PRELIMINARY LANDSCAPE PLAN

ARCO NTI
3400 am/pm
FUEL CANOPY w/ 8 MPD's

SWC S MERIDIAN
@ HIGHWAY 512
PUTALLUP, WASHINGTON

PRELIMINARY LANDSCAPE PLAN

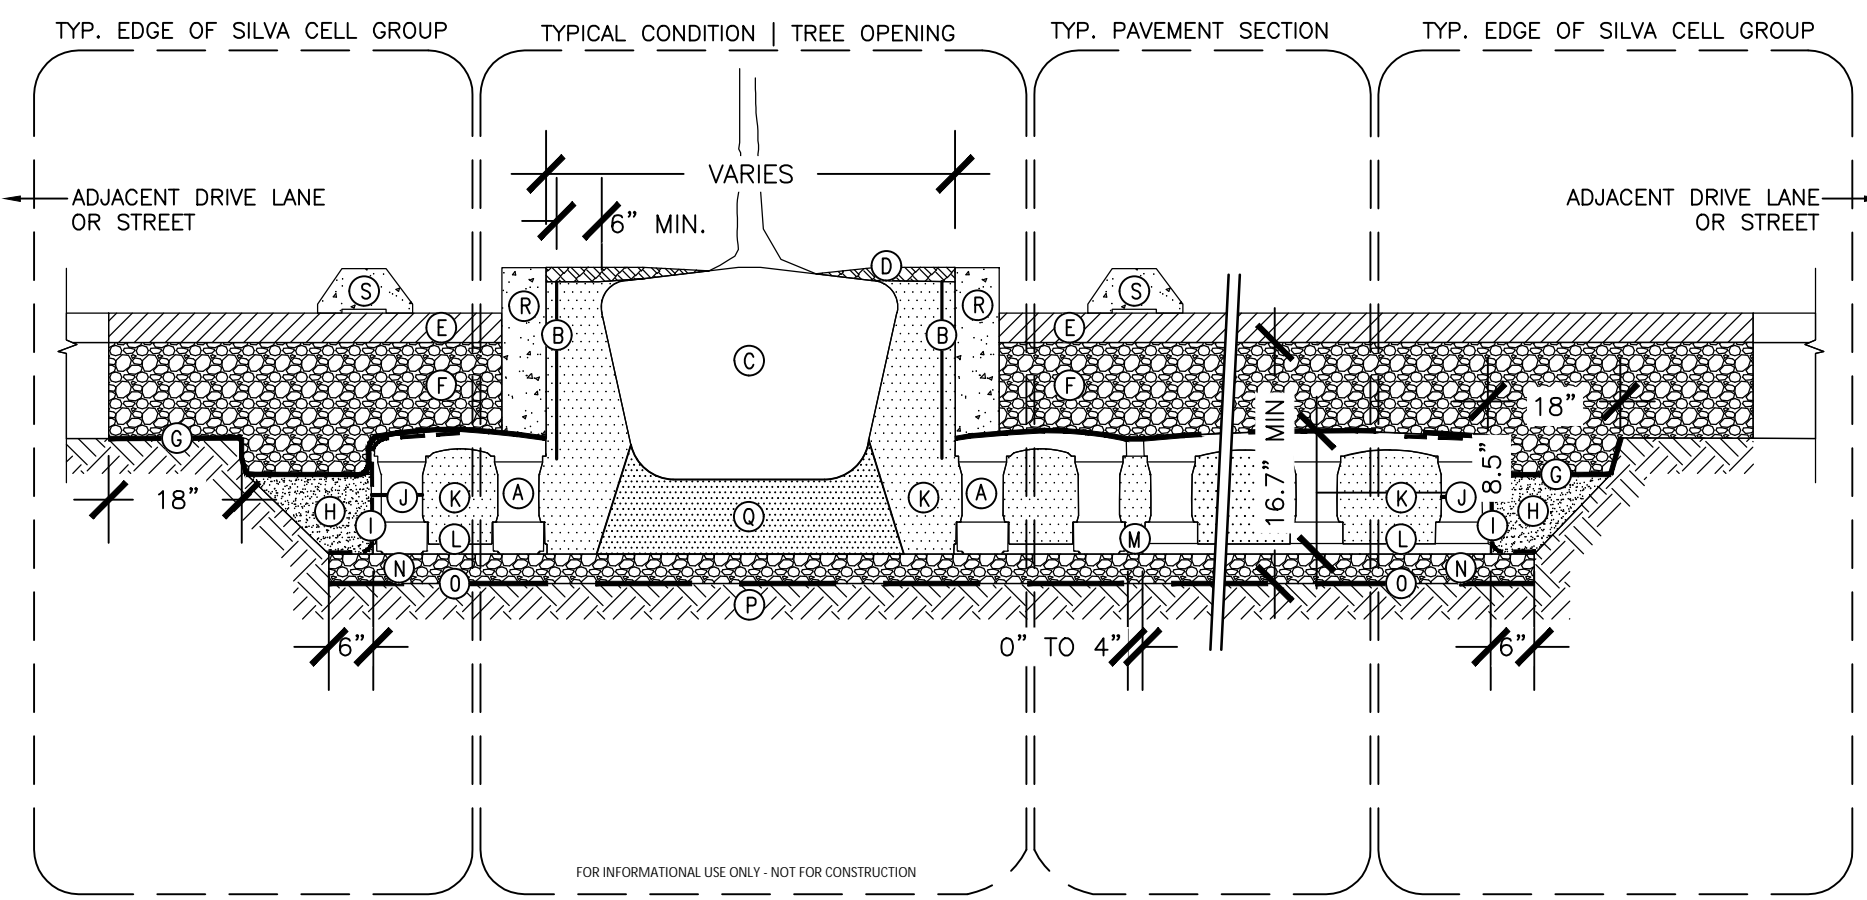
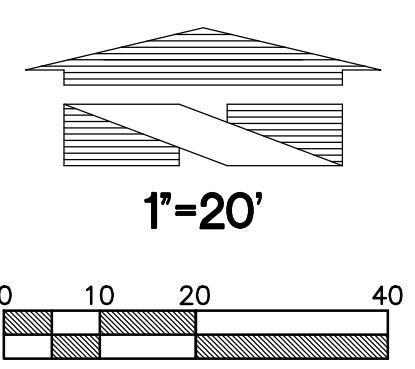
Perimeter and internal landscape islands are not meeting 200SF or 500SF min. areas. All perimeter landscape islands shall be a minimum of 12ft wide with a minimum area of 200 sq ft of area. Each perimeter island shall include a minimum of one (1) tree selected from the Class III or Class IV street tree list shown in section 12.9 or 12.10 of the VMS. All internal landscape islands shall be a minimum of 15ft in width with a minimum area of 500 sq ft. Each internal island shall include a minimum of two (2) trees selected from the Class III or Class IV street tree list shown in section 12.9 or 12.10 of the VMS.; fifty percent (50%) of trees in internal islands shall be Class III or Class IV evergreen conifers. [landscape plan, pg. 1]

Provide calculation for landscape islands internal to the site that are not perimeter landscaping to prove PMC 20.58.005 (1) is being met [landscape plan, pg. 1]

Landscaping along the full length of the western property line is required to be at least 6ft - Type III landscaping. This requirement may be adjusted based on circulation needs. [landscape plan, pg.1]

Establish a defined path of 12ft in width(minimum) leading from the public right-of-way directly to both building entries using decorative/stamped paving (PMC20.26.300 (3.b.ii)) [landscape plan, pg. 1]

Please provide more than one outdoor amenity. Example options are found in PMC 20.30.037 (2)(a) [landscape plan, pg. 1]

Provide landscaping between the property line and the plaza (12ft landscaping) [landscape plan, pg 1]

Provide 12ft landscaping WITHIN property lines. Proposal goes outside of the property lines [landscape plan, pg.1]

No more than eight (8) parking spaces shall be placed consecutively without a landscape island per VMS 14.4 Type IV Design Standards. Since the ADA stall is the eighth stall and room is required for exiting and entering the vehicle, you could place the landscape island between stalls 5&6. [landscape plan, pg.1]

Increase the perimeter landscaping to 12'apos. along entire frontage [landscape plan, pg.1]

Required perimeter landscaping requirements [landscape plan, pg. 1]
